Access Compliance Report

Public Rights-of-Way

(Curb Ramps)

Intersection ID: 50544	Main Street: ALCEA_ST	Cross Street: CAYENNE_DR	Location:	N
ADA ID: 779CC643B7D7	Ramp Type: PerpDiag	Initial Pass/Fail: Fail	Overall Compliance: No	Severity Score: 8.75
Codes/Mitigation Info/Possible Solution		Field Measurements/Component Compliance

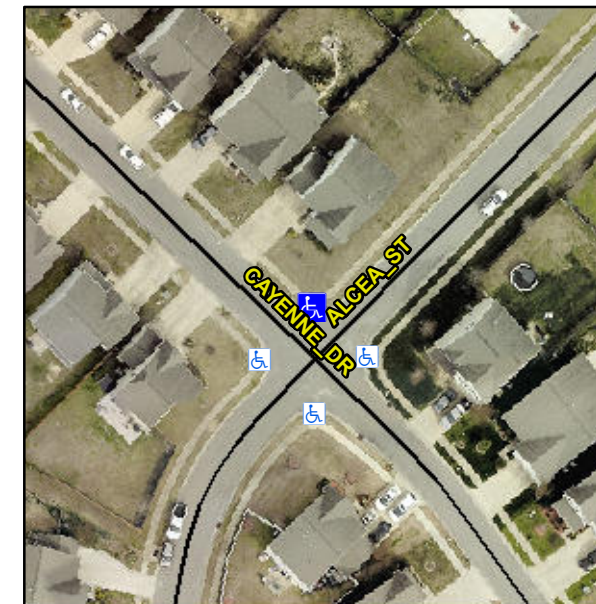
Not Found, R304.5.1

Remove & Replace Curb Ramp With Two New Directional Ramps or Equivalent.
